**MAINE DEPARTMENT OF
INLAND FISHERIES AND WILDLIFE**

**ADDENDUM NO. 3
24-AUG-23**

**IMPROVEMENTS AT GRAND LAKE STREAM STATE FISH HATCHERY
GRAND LAKE STREAM, MAINE**

BGS PROJECT NO.: 3289-14

3 THICKENED SLAB DETAIL
NOT TO SCALE

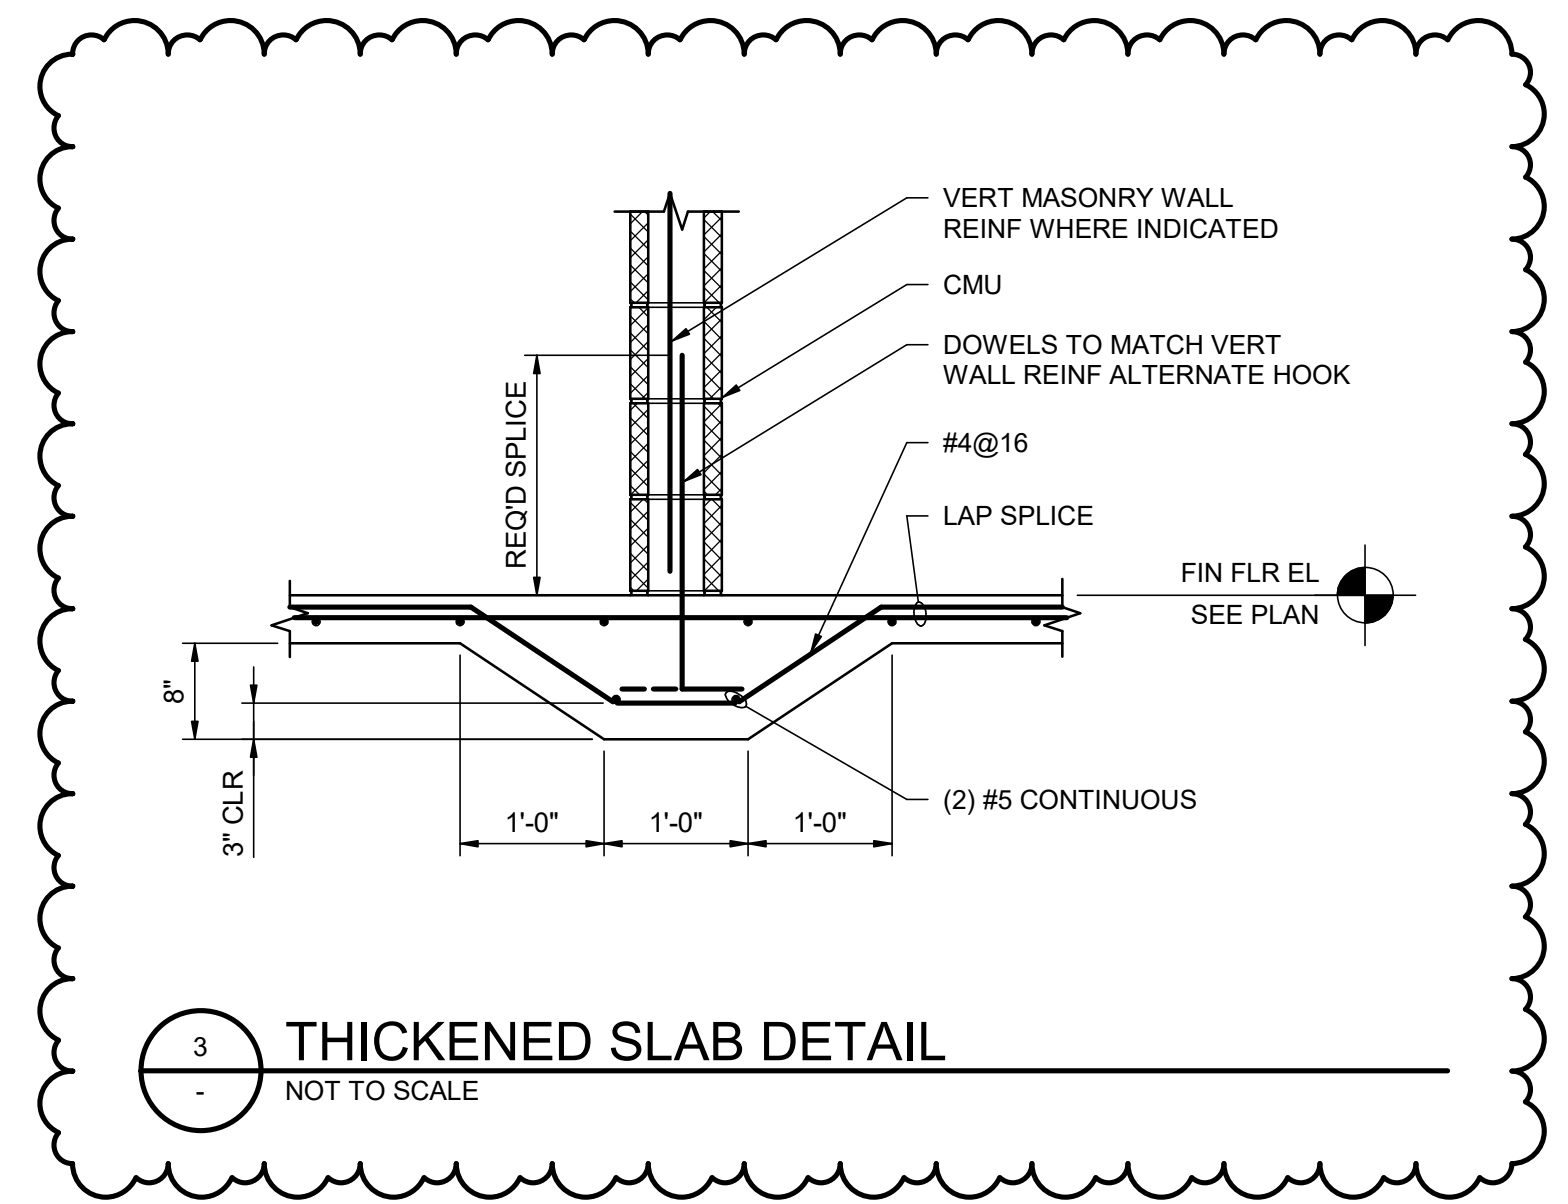
- QUESTION:** Sheet 03s-101 has a section through what I believe is a storage room labeled E/03S-301. Page 03s-301 does not exist, not in the plans or legend.

27. SHEET 00S-103

ANSWER: The reference to 03S-301 is incorrect and should be 3/00S-103.

ADD: Attached detail 3/00S-103 “THICKENED SLAB DETAIL”. See updated plan sheet in this addendum.
